MISSOURI REPLACEMENT 7-006 OF O'FALLON, IR COMPLEX MEDIA CONTRACT NO. 07-DEMOLITION AND PLAN, SECTIONS,

CITY (BIOTOWER

DESIGNED: DRAWN: CHECKED: JOB NO. REF. NO. SHEET **5** OF **12**

SHOWN ON THIS PLAN SHALL BE "TO REMAIN". BACKGROUND DRAWING TAKEN FROM GBD DWG. 34 OF 88 GARAGE-ROOF FRAMING PLAN SCALE: 3/16"=1'-0"

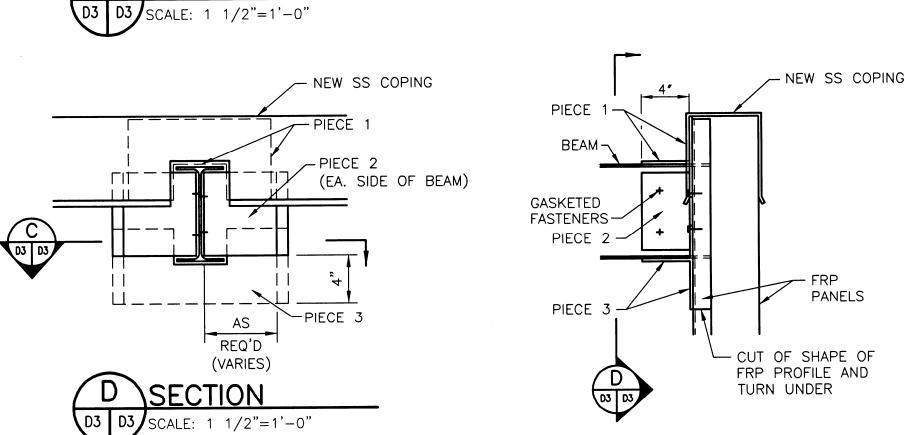
Nest to east @141/11.

Provide bridging per 511 recommendations Provide

'x' bridging first two bays on north end, provide horizontal bridging elsewhere.

Bolt Joist conn.

of end oupport

per Sul rec 3" 15"
